RE: Camden Medical Precinct - Traffic and Parking Impact Statement – Addendum 1

This statement has been prepared as an addendum to the Traffic Impact and Parking Assessment (TIA) to support a Development Application (DA) for the proposed Camden Medical Precinct, dated 1 July 2016, to reflect changes to the proposed development under a Section 4.55 modification of the operative development consent (ref: SSD_7387).

Figure 2.1 Hospital Basement Parking

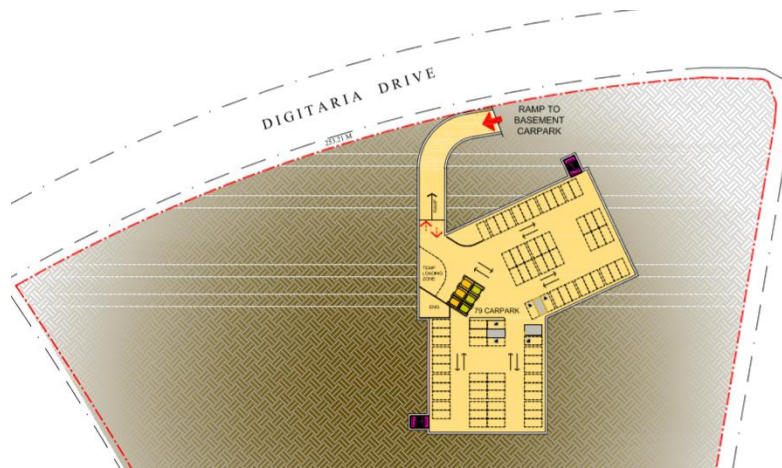
The approved parking allocation for the whole site (hospital and biomedical research unit) is 1,080 spaces. There have been minor alterations to the car parking allocation following the design changes, however more significant changes to locations and layouts of parking facilities. The relocation of the multi-level parking facility to the hospital site is a positive outcome for pedestrian movement around the precinct. The direct pedestrian access achieved to the main hospital building from the parking facility removes all pedestrian-vehicle conflicts. Figure 2.1 and Figure 2.2 show proposed locations of the car parking facilities.

Table 2-3 shows the allocation of car parking as distributed over the basement, on-grade and multi-level parking facilities. The proposed design provides 885 parking spaces for the hospital site, 59 more than the requirement. This parking allocation

includes 5 accessible parking spaces and more will be designated utilising the surplus of spaces provided.

Figure 3.1 Biomedical Research Building Basement Parking

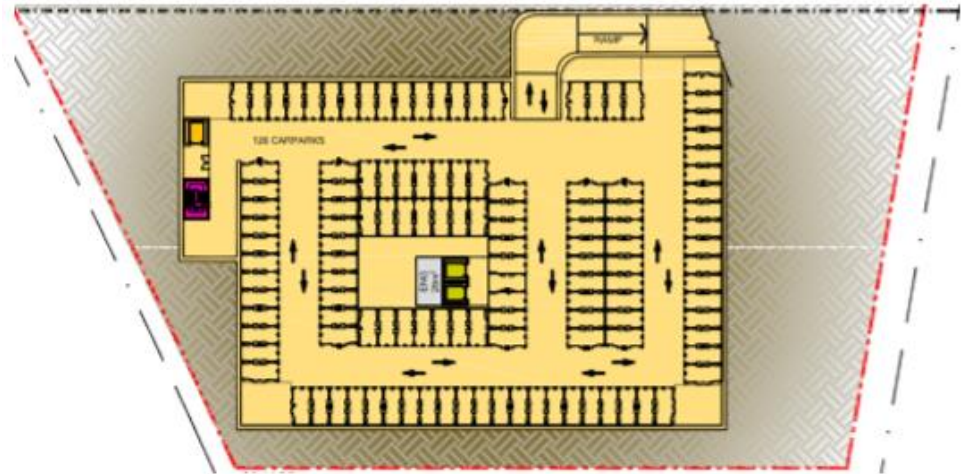
69 car parks have been provided on-grade over two locations on the research building. Additionally, the basement to the research building provides car parking for 126 vehicles, 7 of which are proposed as a stacked arrangement. The parking plan is illustrated in Figure 3.1 and Figure 3.2.

The current design has a total parking provision of 195 spaces, exceeding the requirement of 167. It is proposed to replace a portion of the standard spaces with accessible spaces to meet the minimum parking requirement of both.
